**NOTICE OF PUBLIC REVIEW AND INTENT TO ADOPT  
A PROPOSED MITIGATED NEGATIVE DECLARATION (Revised)**

County File No. CDS20-09531

**PROJECT NAME:** Grayson Road 10-Lot Subdivision (County File #CDS20-09531)

**PRELIMINARY GRADING,  
DRAINAGE AND UTILITY PLAN**

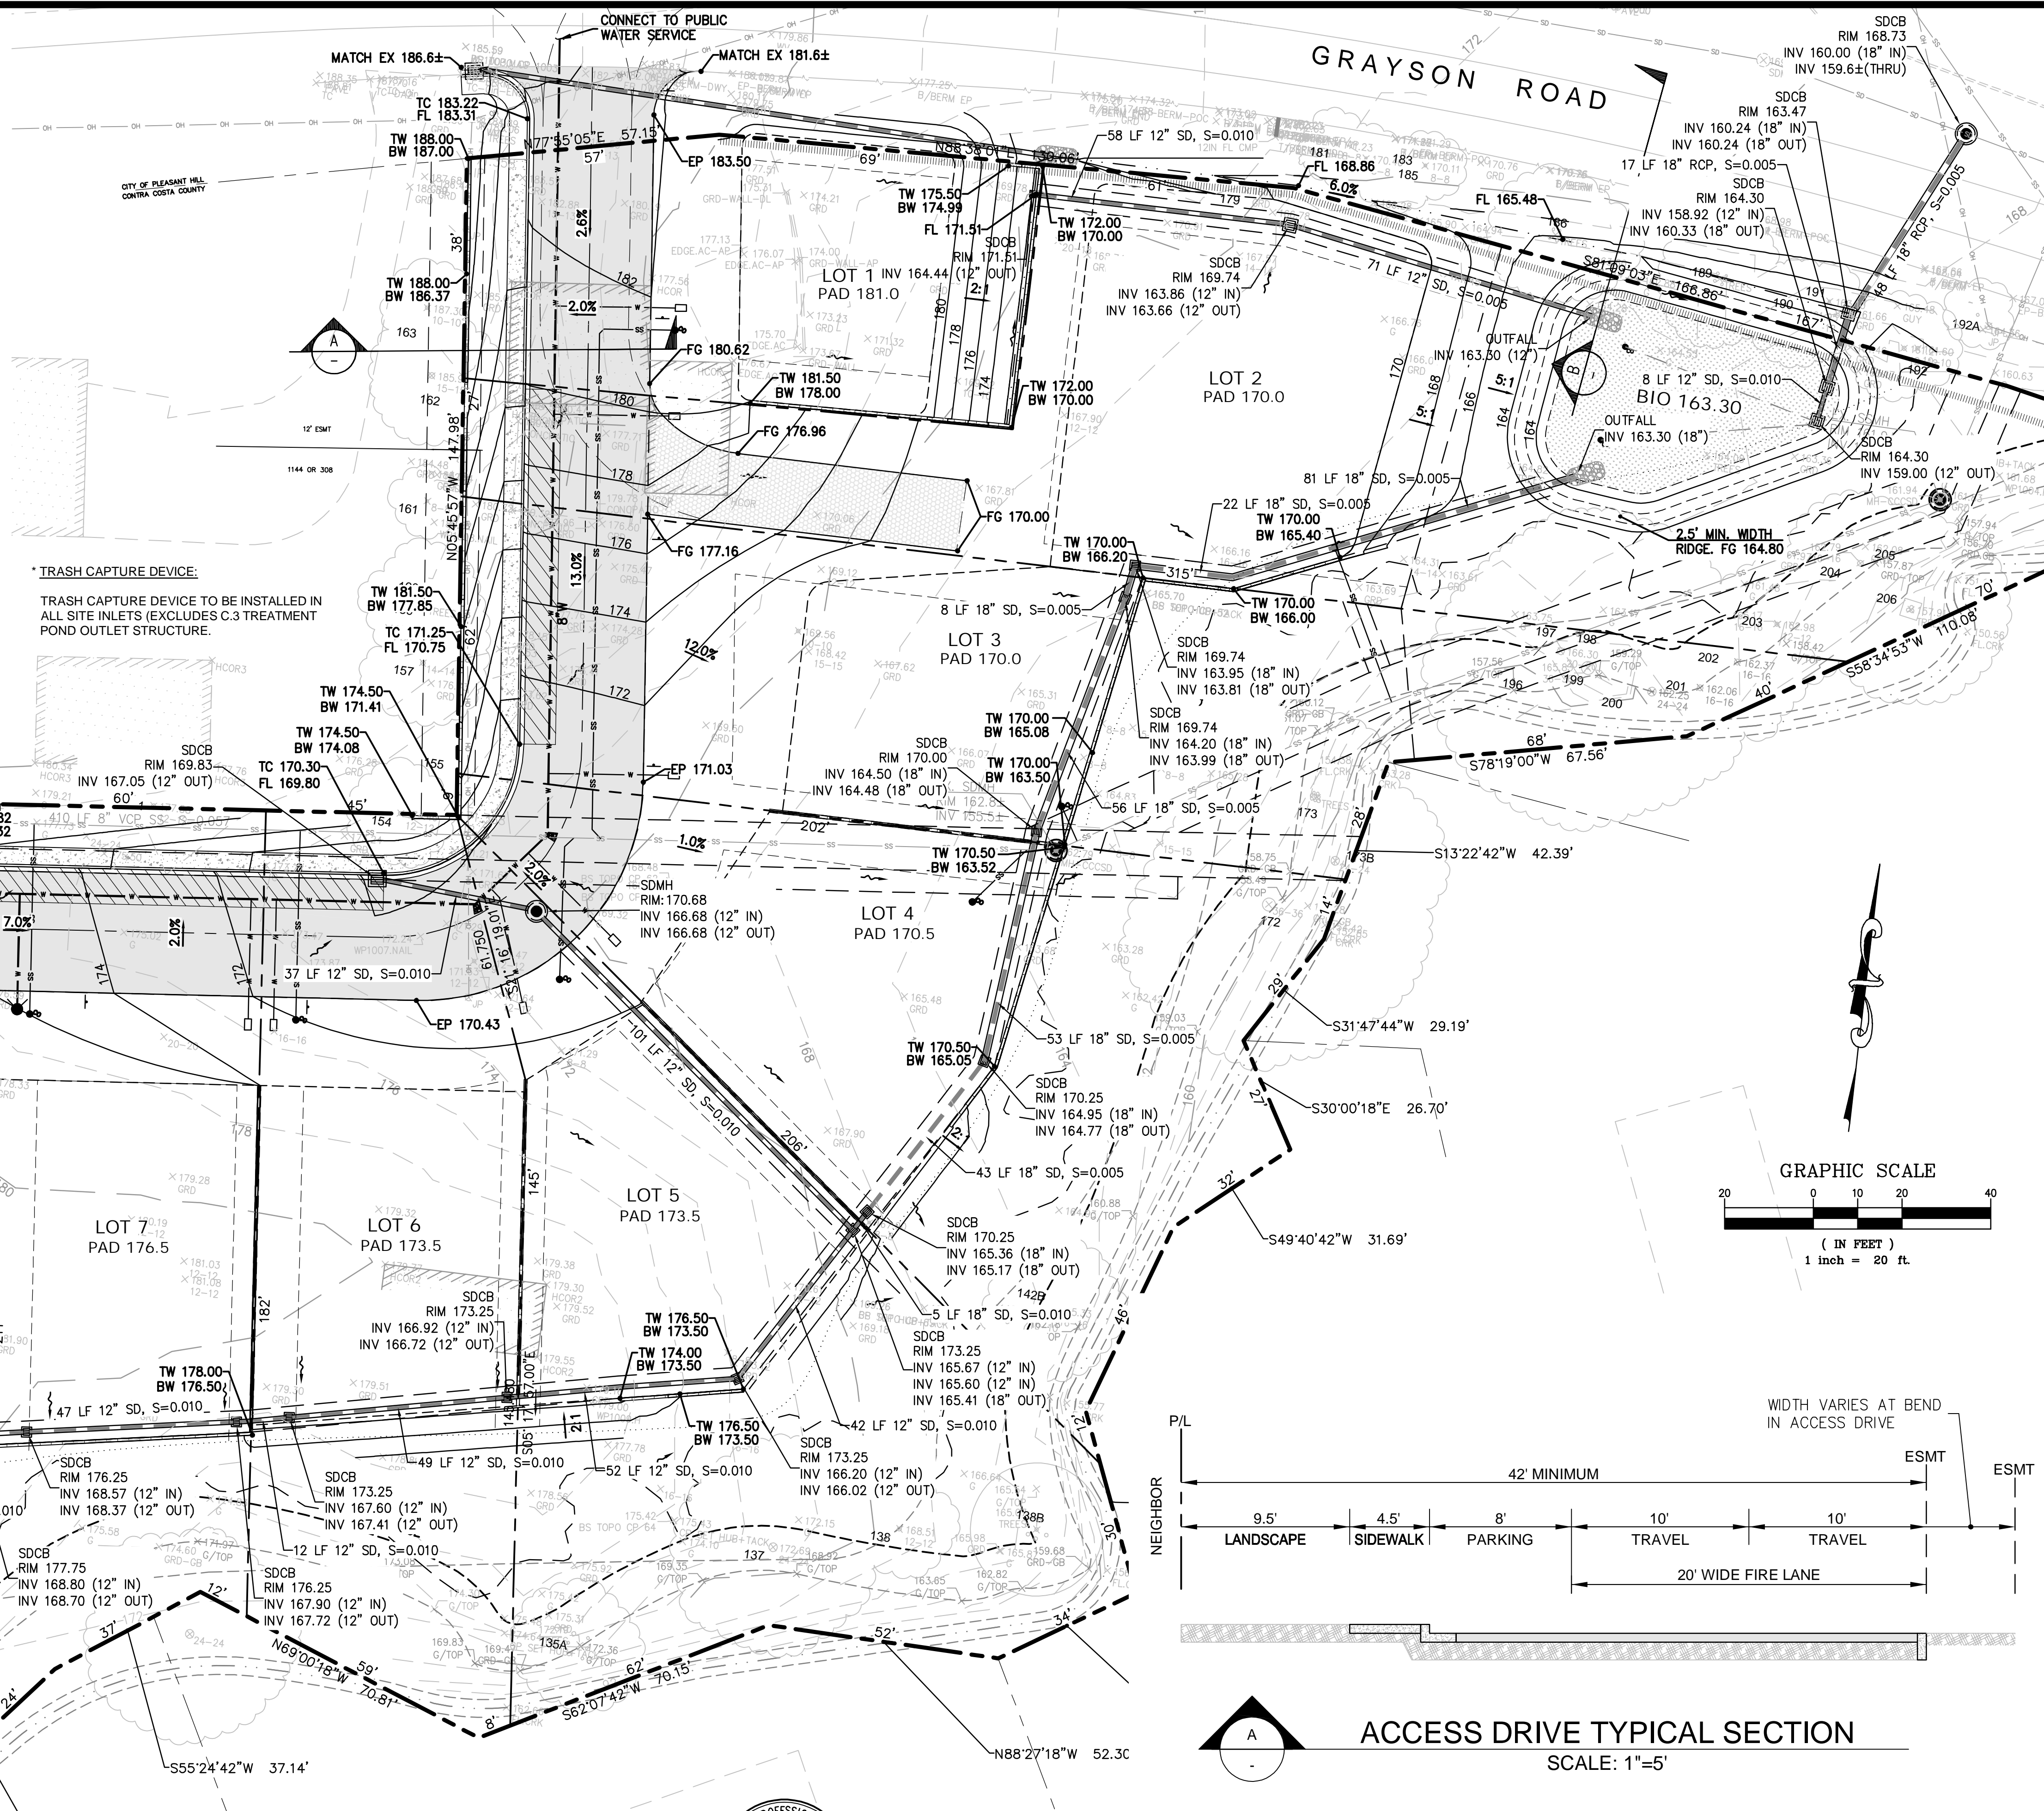
- b) The MND contains no description of how the riparian setback was established, and no description of the width of the riparian setback from the creek channel, centerline, or from the top-of-bank. Neither the creek centerline nor the top-of-bank are shown on the development plans (or perhaps they are just not labeled). As shown on Figure 11 in the biological report, in some locations the top-of-bank is either commensurate with or extends beyond the riparian setback, which apparently is the drip line of the trees that were determined to comprise the northerly boundary of the riparian corridor. Policy 8.89 of the general plan Conservation Element requires a minimum 50-ft. setback from the centerline of Grayson Creek. How does the proposed riparian setback compare to the minimum 50-ft. setback?

Mitigation Measure Biology 6 states that the riparian setback area will be deed restricted, precluding any kind of development, including grading. Sheet 1 of the project plans shows the limit of the riparian area with a note that no grading will be allowed. Beyond that line, Sheet 1 shows the creek structure setback line labeled with a note that states developer to relinquish development rights within creek structure setback area. It would appear that grading would be allowed within the creek structure setback area, which would mean that grading would be allowed up to and beyond the top of the creek bank, which is inappropriate, and demands the extension of the riparian setback area to a point well beyond the top of bank.

It appears in Mitigation Measure Biology 6, Sheet 1, that grading will be allowed within the creek setback area. This is completely irresponsible. The riparian setback should be extended well beyond the creek bank by at least 50’.

The commenter states that Figure 11 of the Biological Report shows the top of bank either commensurate with or extending beyond the riparian setback, which apparently is the drip line of the trees that were determined to comprise the northerly boundary of the riparian corridor. The commenter cites Policy 8.89 of the General Plan Conservation Element requires a minimum 50-foot setback from the centerline of Grayson Creek. The commenter asks how the proposed riparian setback compares to the minimum 50-foot setback.
